# **87C196KQ SPECIFICATION UPDATE**

Release Date: January, 1997

Order Number: 272837-002

**Figure 1. 16-bit System with EPROM**

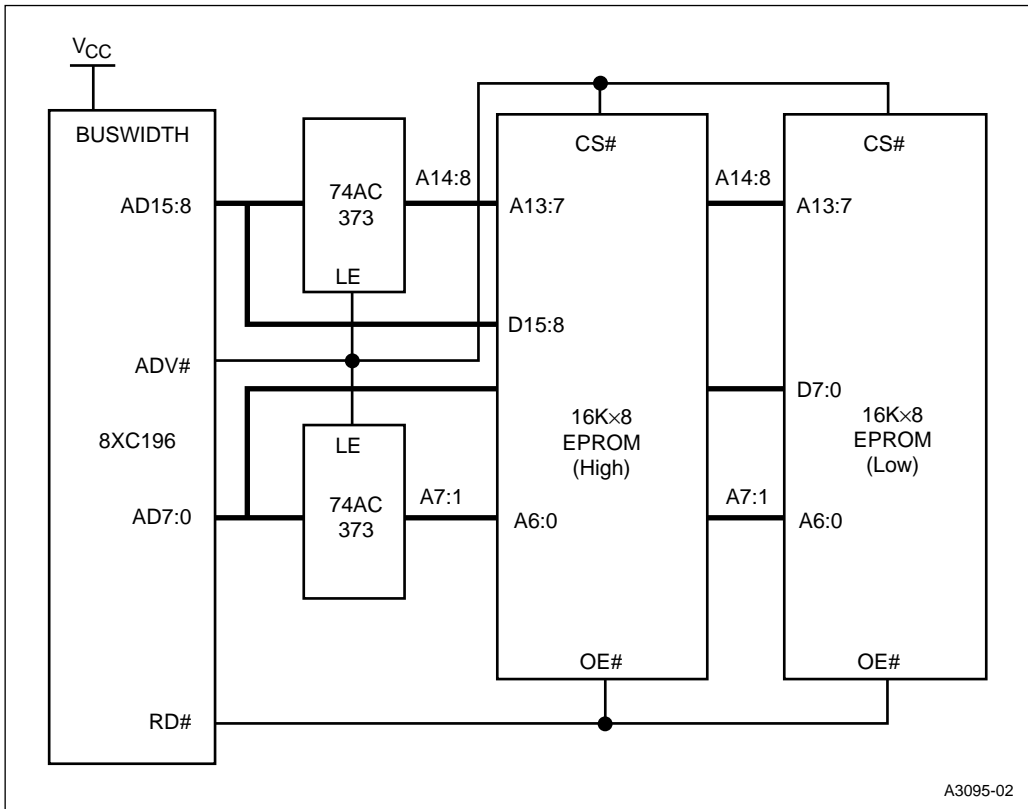
- 001.**        *High address inputs to the low EPROM should be A14:8 in Figure 15-18.*

**ITEM:** The next revision of the user's manual will include the following corrected graphic.
